Reference Number: 20253

**RE: Transportation Impact Assessment (TIA) Update
Proposed Seniors Residence Development
1280 Dundas Street West, Town of Oakville**

Appendix A – City Comments

Figure 5-1: Pedestrian Circulation Plan

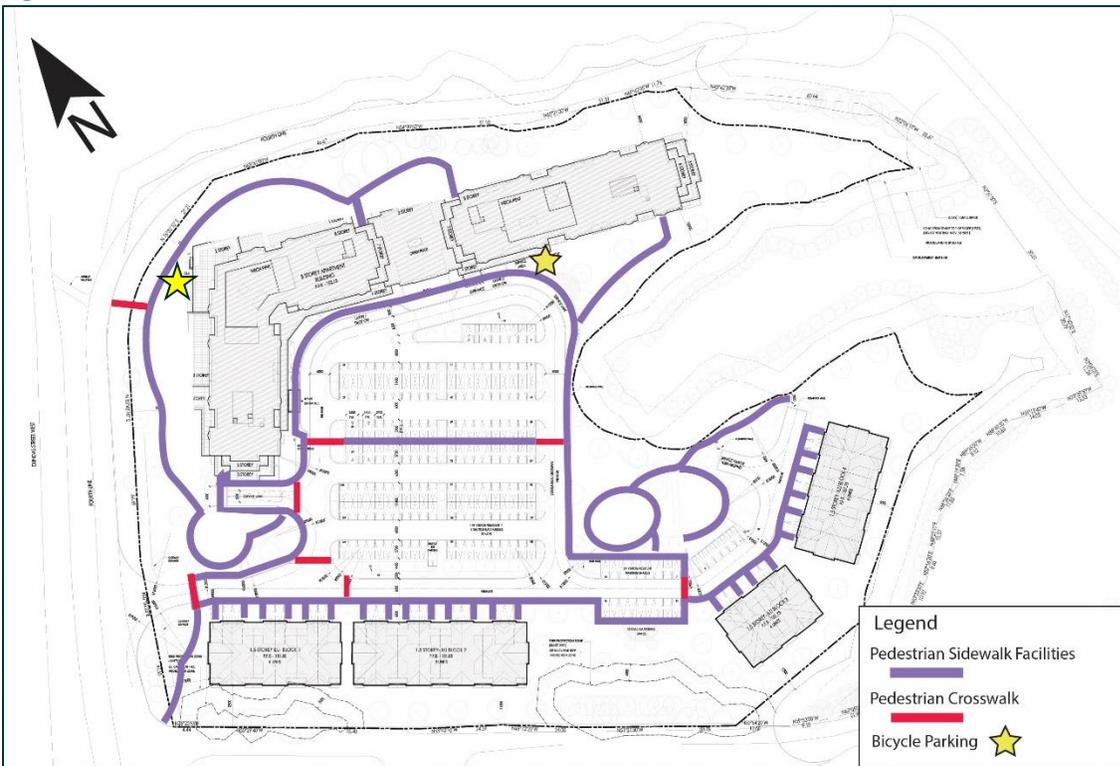
As requested by Transportation Services, LEA has provided a pedestrian circulation plan to highlight the pedestrian circulation throughout the proposed development, including the sidewalk facilities, bicycle parking, and pedestrian crosswalks available.

Figure 5-1 illustrates that there is good pedestrian circulation located within the proposed development, with multiple pedestrian connections proposed to the surrounding trail system providing opportunities for active transportation, including cycling and walking. The proposed development is located along Dundas Street West, which is an identified transit route with a multi-use trail. Bicycle parking is also proposed to be located adjacent to the apartment building entrance, offering easy accessibility for pedestrians to utilize the cycling network in the surrounding area. In addition, as requested by Transportation Services, the architect has included a pedestrian sidewalk connection across the main driveway to Fourth Line for people needing to access the bus stops along Dundas Street is included in the proposed development.

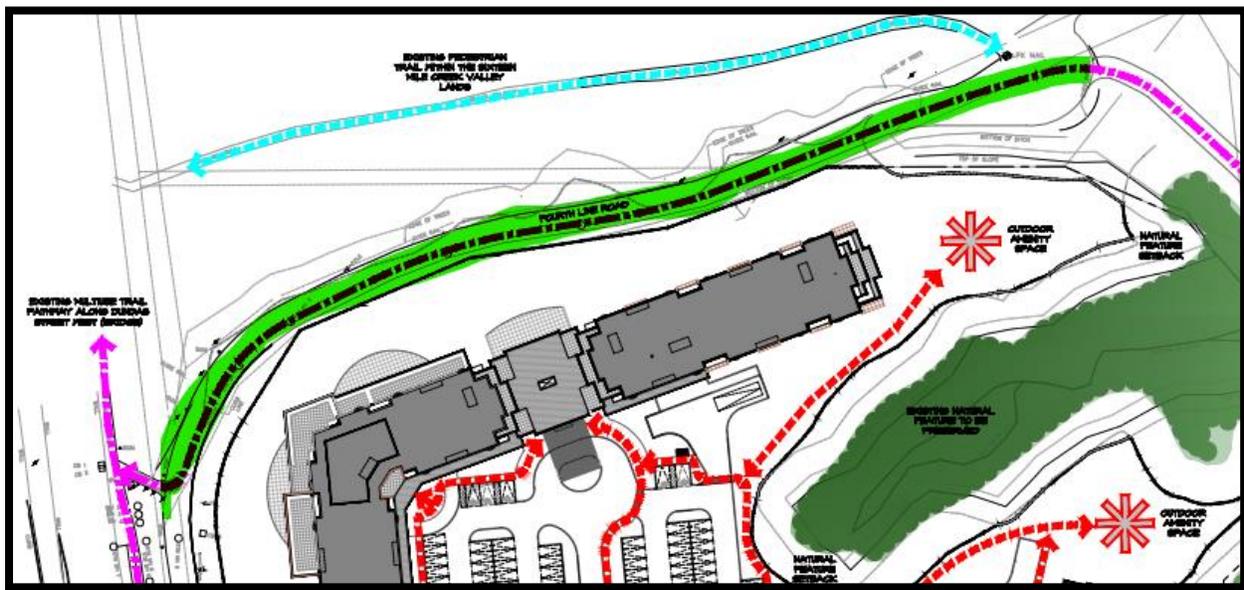
1. [Circ. 1] The pedestrian circulation plan should be updated to reflect that there is no MUT where highlighted in green below, this is an active road and no current pedestrian facilities exist.

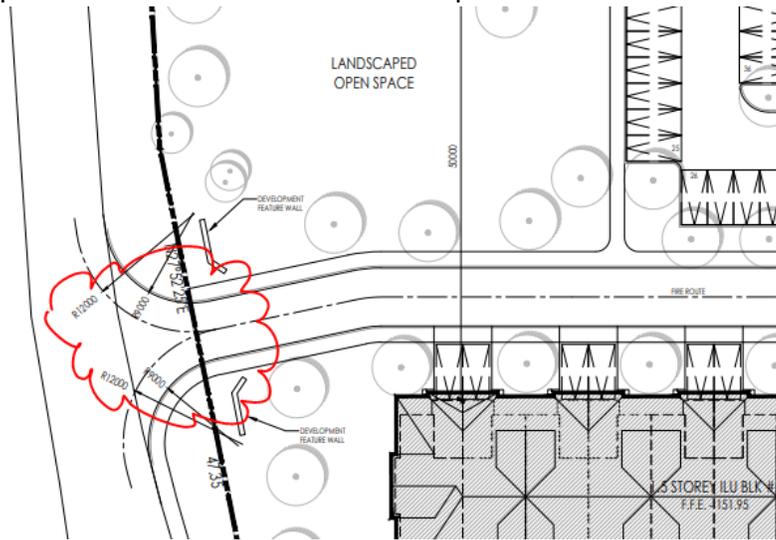
- a. Please provide autoturn analysis for the 26ft specialized transit vehicle on site at the circular driveway at the front door. The specifications for the bus (Arboc Specialty Vehicles, Spirit of Freedom model) are:

- i. Length: 8.2m over bumpers
 - ii. Width: 3m including mirrors, 2.4m excluding mirrors
 - iii. Outside body turning radius: 10.5m including bumper
 - iv. Height: 3.05m

- b. Please confirm the height clearance of the canopy over the circular driveway at the front entrance.
2. [Circ. 1] Please provide details of the curb types around the circular driveway in the site plan. care-A-van would prefer both barrier curb and flush curb. The care-A-van buses can deploy a ramp onto a barrier curb to minimize the slope. Rides provided by contracted taxi would need to use a flush curb.
